Appendix E

Alternative Power Line Route Option

Modification 4 includes the 132kV Reinstated Transmission Line to be located within an assessed 100m wide corridor. During the Modification 4 exhibition period a neighbouring landholder contacted the Proponent with a suggestion for an alternative route corridor option for a short section of the Reinstated Transmission Line (see Figure E1 below).

Figure E1: Alternative Route Option Corridor

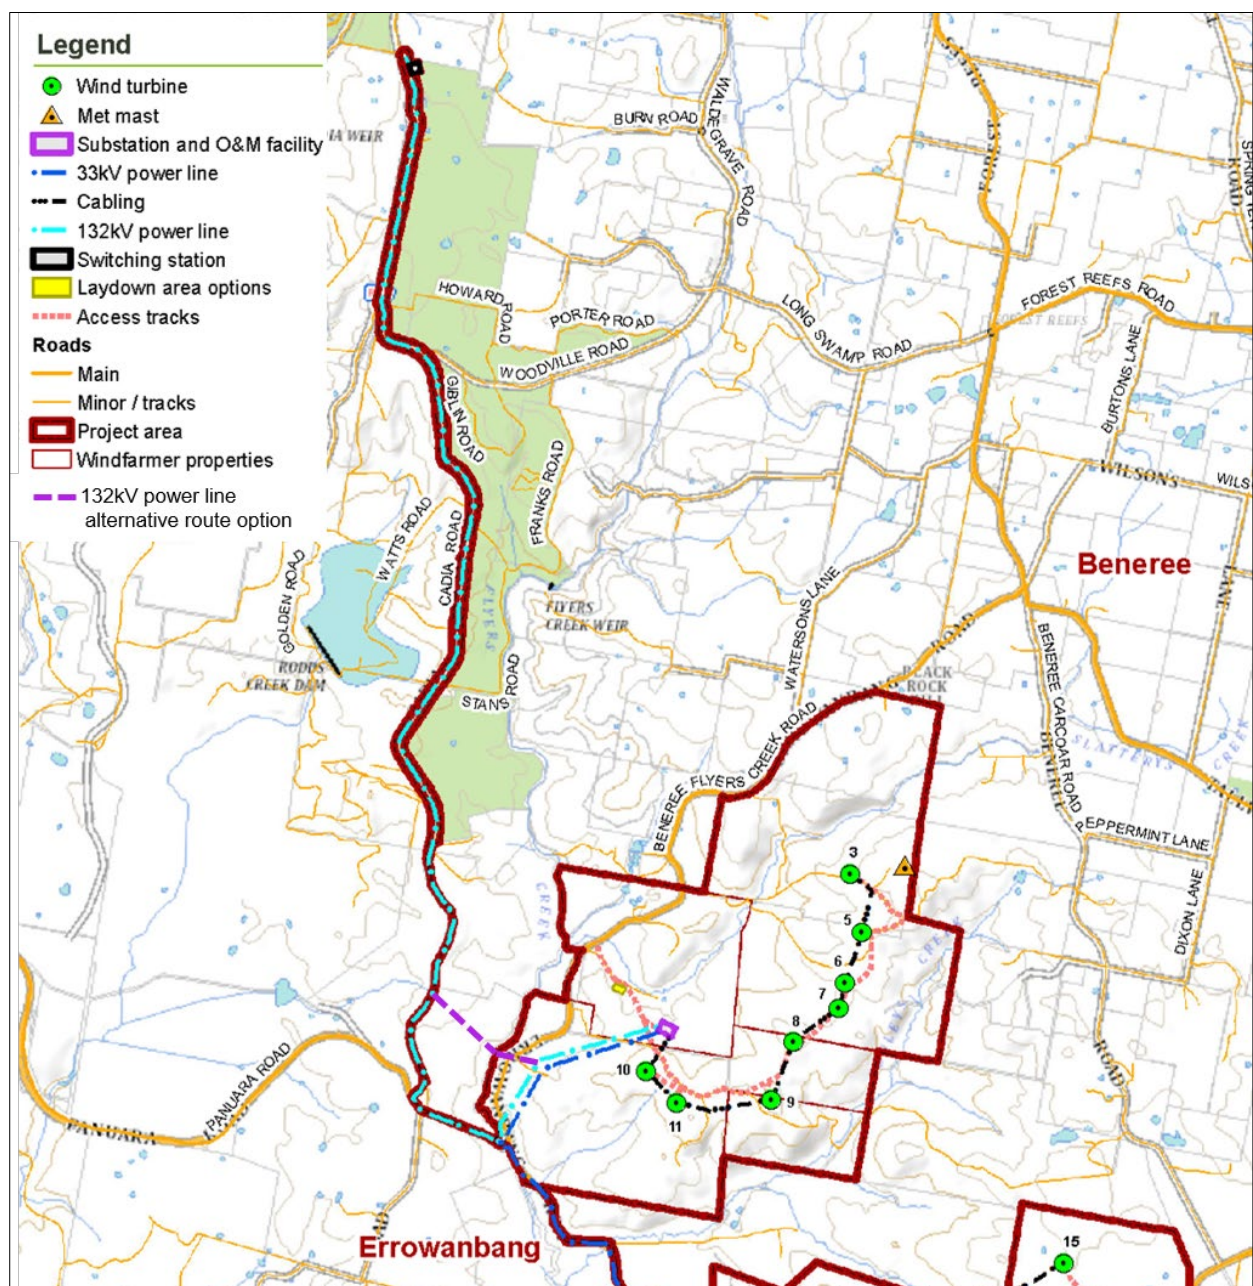
The proposed alternative route option for the relevant section of the Reinstated Transmission Line route corridor is shown in Figure E1 and Photograph E1. It would, if selected as the final preferred option for the Reinstated Transmission Line during detailed design, replace an approximately 3.1km section of the route corridor assessed in the Modification 4 Environmental Assessment which travels across rural land (improved grazing pasture), the Errowanbang Road and Flyers Creek and then travels along the Panuara Road and Cadia Road reserves.

This section of the route corridor assessed in the Modification 4 Environmental Assessment which would be replaced if the alternative option is selected as preferred is an approximately 1.3km section of power line which would travel across rural land (improved grazing pasture) in a north westerly direction, crossing the Errowanbang Road, Flyers Creek and then re-join the currently proposed route corridor at the Cadia Road.

The proposed alternative section of power line would be located approximately 1km north of the existing proposed location of the power line and would, if selected as preferred, essentially replace a 'u' shaped section of the line with a direct route, resulting in a reduction in the overall length of the currently proposed power line by approximately 1.8km.

This option offers the potential for reduced impacts and so has been included as part of Modification 4 as an alternative for the corresponding section of the route corridor assessed in the Modification 4 Environmental Assessment. The final route for the Reinstated Transmission Line will be selected from these two alternative options as part of the ongoing detailed design of the Project and following finalisation of relevant landholder negotiations.
